How Not to Instal Fire Dampers

extract from a tier 1 Mechanical Engineer's design drawing.

HORIZONTAL FIRE DAMPER IN SLAB
N.T.S.

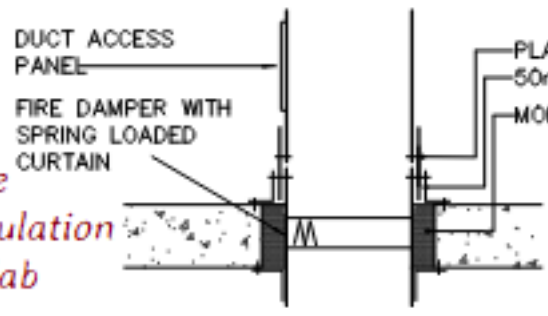
Where is the required insulation above the slab

Rivots - it's rivets
Mortar is a forbidden infill

HORIZONTAL FIRE DAMPER IN SLAB WITH INSULATED DUCT
N.T.S.

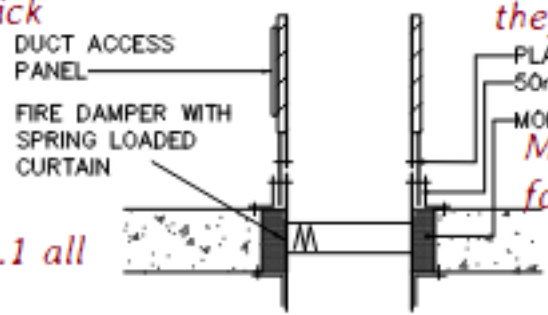
How does this give not less than 2m 50mm thick 1000 degC rockwool insulation as required by AS/NZS1668.1 all versions

Rivots - it's rivets & they'd be aluminium
Mortar infill is forbidden
